Executive Order G-70-23-B

Relating to the Modification of the Certification of the
Exxon Balance
Phase II Vapor Recovery System

Executive Order G-70-23-*B*

Exxon Phase II Balance

Exhibit 1

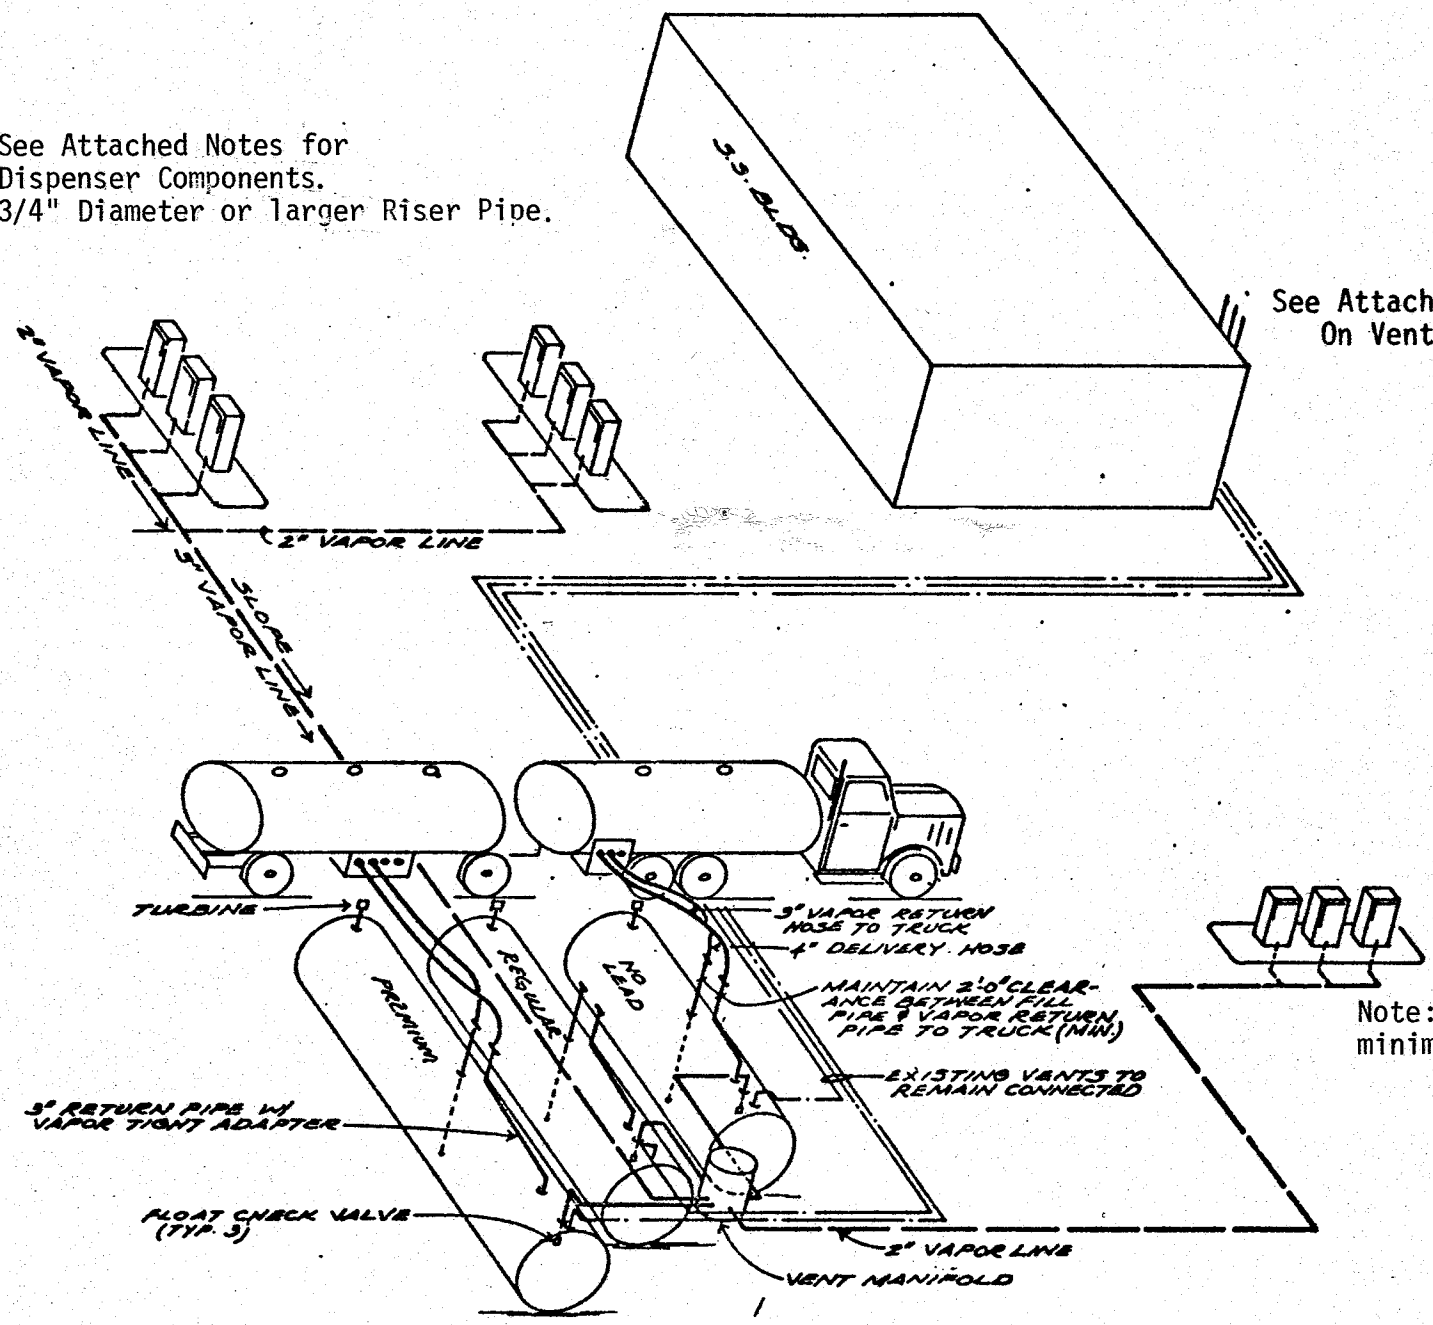
IT IS ORDERED AND RESOLVED: That the certification Executive Order G-70-23-A issued on December 6, 1978, for the Exxon balance Phase II vapor collection and disposal system is hereby modified to eliminate the previously allowed use of a single OPW 78 series recirculation trap on dual dispensers dispensing the same product from both sides. The system hereby modified is certified to be at least 95% effective in self-serve and/or attendant use at gasoline service stations in conjunction with Phase I vapor recovery system which have been certified by the Air Resources Board. The system is described in Exhibits 1 and 2, attached hereto.

~~10. On dual dispensers dispensing the same product from both sides, the vapor return lines may be connected to a single OPW 78 series recirculation trap.~~
